# ***Interactive comment on “Satellite soil moisture data assimilation for improved operational continental water balance prediction” by Siyuan Tian et al.***

## Response to Anonymous Referee 2

**Fig. 1.** Quantified impacts of data assimilation on forecasting AWRA-L state variables using the initial condition from DA-TC:

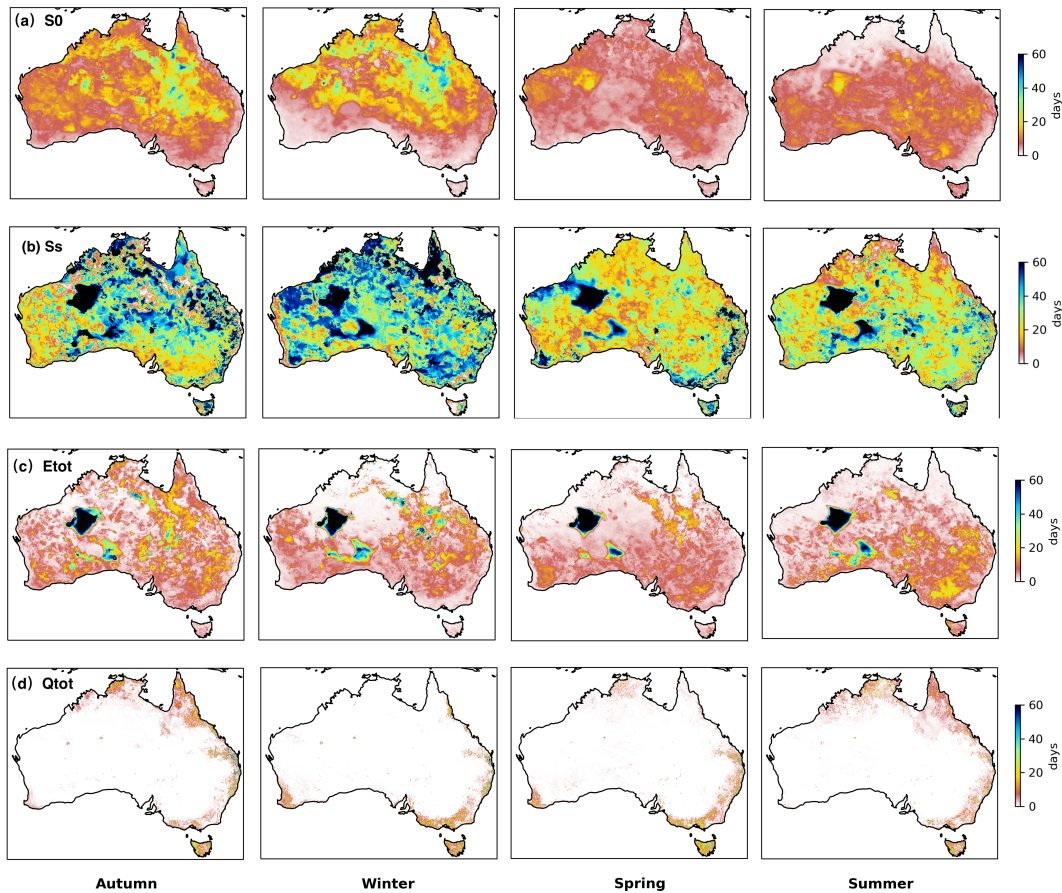
Section 4.4 \* The authors evaluate the persistence of data assimilation through comparison of the open loop and DA-TCAIR. Could the authors also include the DA-TC in this analysis? I would be interested to see what AIR in itself does to the persistence of the soil moisture data assimilation. This would potentially also support the use of DA-TCAIR over DA- TC.

Thank you for the suggestion. The results of DA-TC are shown in Fig.1 below. In comparison with manuscript Figure 10, you will note that the results of DA-TCAIR and DA-TC for the upper layer soil water storage are the same (perhaps obvious since AIR does not change top-soil layer). However, DA-TCAIR does change Ss, ET and Q<sub>tot</sub>, which can be seen to be quite different to the DA-TC results below. To save space, we suggest including the figure below as supplementary materials, however we will leave the final decision to the discretion of the Editor.

**Fig. 2.** (a-c) Comparison of correlations between vegetation greenness (NDVI) with AWRA-L modelled root-zone soil moisture over cropland (a-c). (e) Time series of NDVI and root-zone soil water storage in (d)

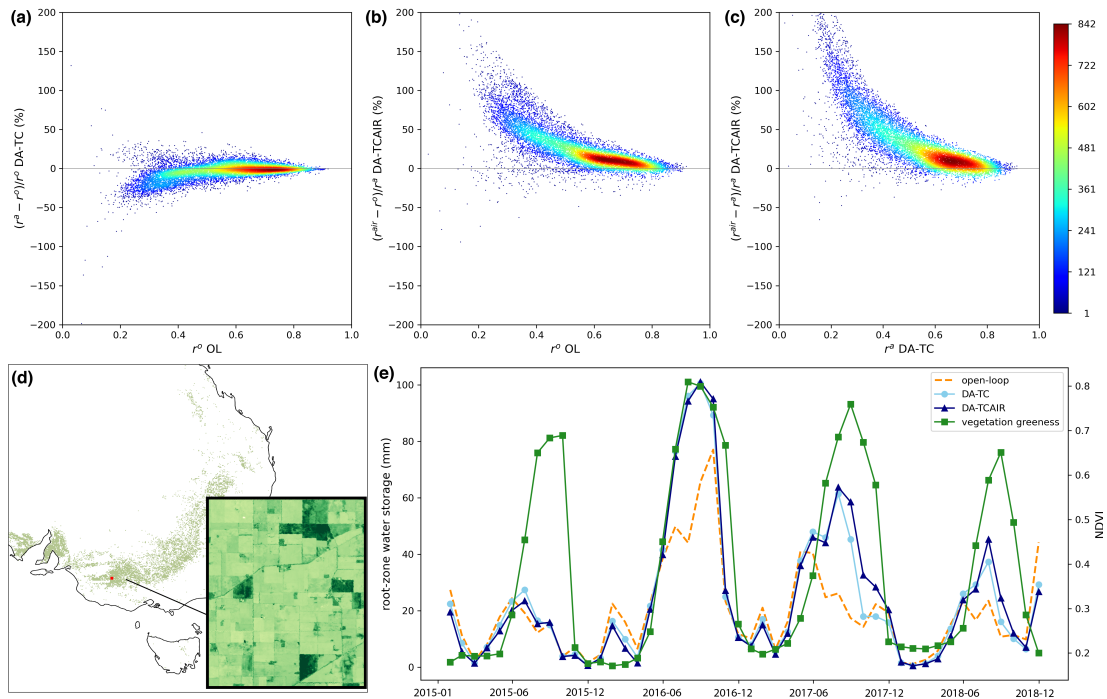
L15: Could the authors provide also correlation coefficients for the comparison of the root zone soil moisture and vegetation time series? Instead of only the increment.

Thank you for the suggestion. In L287, we included that the correlation of root zone soil moisture from DA-TC with NDVI is 0.55 on average, while the correlation of DA-TCAIR is 0.66. We will include a averaged time series plot for a small region (15km x 20km, origin:(-36.25, 142.15)) as an example in the revised manuscript, since taking the average of all the cropland grid cells across the continent is not appropriate.

The revised figure is shown in Fig.2. The correlations of the region are 0.47, 0.68 and 0.74 for the open-loop, DA-TC and DA-TCAIR respectively.

**Fig. 3.** Time series of AWRA-L surface soil water storage estimates from open-loop (OL) compared to estimates after data assimilation (DA-TC) of SMAP and SMOS soil moisture retrievals at CosmOz monitoring site

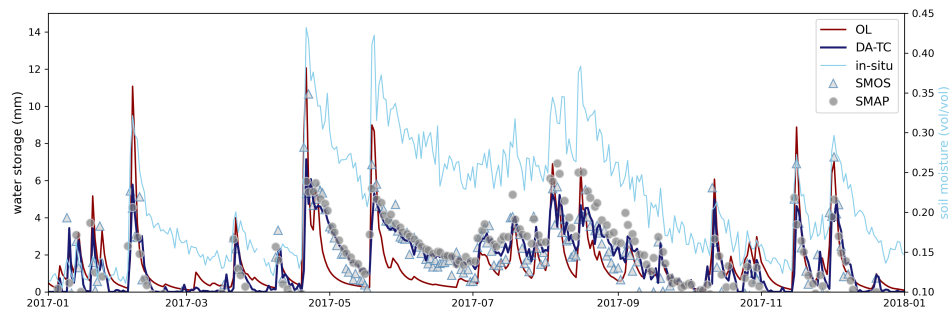
Figure 3: Could the authors add a time series of the measured soil moisture to this figure.

Yes. We will include the in-situ measurements in this figure as shown in Fig.3.

**Fig. 4.** Comparison of daily average surface soil water storage estimates ( $S_0$ ) for December 2019 from (a) OL, (b) DA-TC and (c) difference between DA-TC and OL

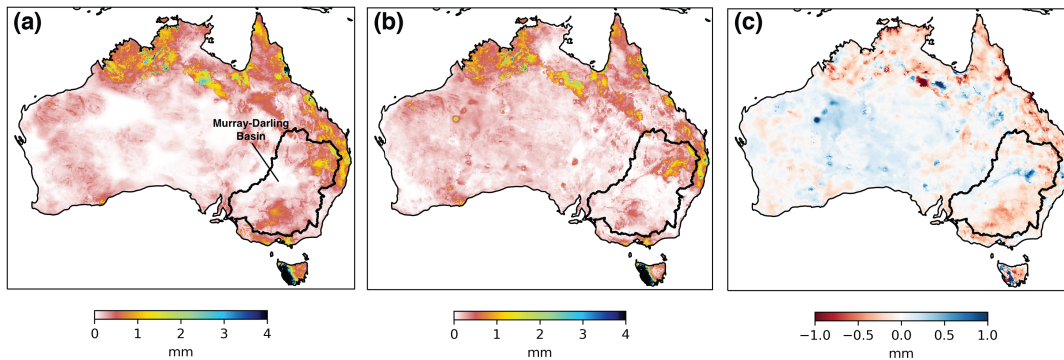
L226: Could the author indicate where the Murray-Darling Basin is? Readers not familiar to the continent may not know where it is.

Yes. We will include the boundary of the Murray-Darling as shown in Fig.4.
